**Re: Notification of Data Availability and Request for Comment:
*Energy Conservation Program: Energy Conservation Standards for
Consumer Water Heaters, EERE-2017-BT-STD-0019, RIN 1904-AF65,
89 Fed. Reg. 59692 (July 23, 2024)***

The American Gas Association (“AGA”), American Public Gas Association (“APGA”), and National Propane Gas Association (“NPGA”) (collectively, “Joint Commenters”) respectfully submit these comments in response to the above-referenced proceeding regarding the notification of data availability and request for comment (“NODA”) pertaining to energy conservation standards for consumer water heaters issued by the U.S. Department of Energy (“DOE”).¹ Joint Commenters raise various material issues with the NODA, particularly the fact that DOE currently relies on data used in rules designed for other natural gas appliances and not gas-fired instantaneous water heaters (“GIWHs”). Due to these critical issues, DOE should restart the rulemaking process for GIWHs, or at minimum issue a supplemental notice, that contains analysis with the appropriate data and addresses the concerns discussed herein.

Venting Design as Described in DOE's TSD: Misalignment with Horizontal Installations (Figure 8D.3.3)

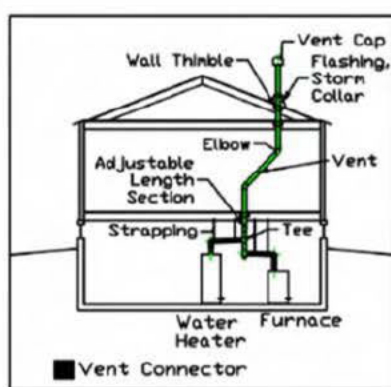
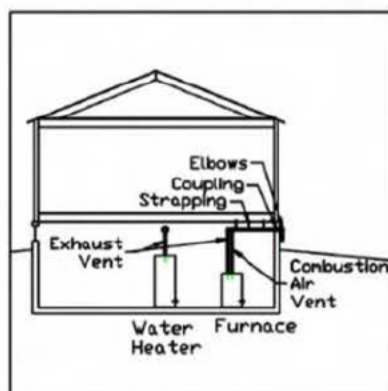
labor costs due to the complexity of vertical installations. This assumption fails to account for the fact that GIWHs do not universally require such extensive venting solutions.

Moreover, while DOE's model includes cost data for alternative, more cost-effective materials like double-walled aluminum flex pipe—which is approximately half the cost of stainless steel—it does not apply these alternatives in any of the 10,000 trial scenarios. This oversight skews the cost-effectiveness analysis, leading to an inflated estimate of installation costs that does not accurately represent the variety of real-world installation scenarios for GIWHs.

The DOE model identifies 86% of all GIWH installations in the 10,000 trials as horizontal, with the remaining 14% utilizing vertical vent designs like those used by non-condensing furnaces, typically spanning 10 to 20+ feet. However, the model likely overestimates the percentage of vertical installations for both new and replacement GIWH installations. The economic advantages of new non-condensing GIWH systems typically favor horizontal venting over the more complex and costly vertical Category I venting systems used by other water heaters. Fixing the overestimation of new GIWHs installed with vertical venting, especially long 20+ foot length installs, would reduce average Life Cycle Cost ("LCC") savings further.

Despite recognizing that 86% of installations are horizontal, the DOE model inaccurately applies the same labor and material costs to these installations as it does to vertical installations. This results in an overestimation of costs for horizontal installations, which are generally much simpler than vertical installations. The average horizontal system requires less than 7 feet of venting and follows a straightforward work plan, like that of a condensing unit. Such installations typically involve connecting just 3 or 4 individual parts through a wall, drastically simplifying the process compared to the more complex Category I vented storage water heaters or non-condensing furnaces.

The model assigns Efficiency Level 0 (“EL0”) to 30% of trials—of which about 10% involve vertical venting in the base case. For the horizontal EL0 GIWH installations, the model assumes the same labor and part requirements for vertical installations, failing to reflect the simplicity and lower cost of horizontal venting designs in general.
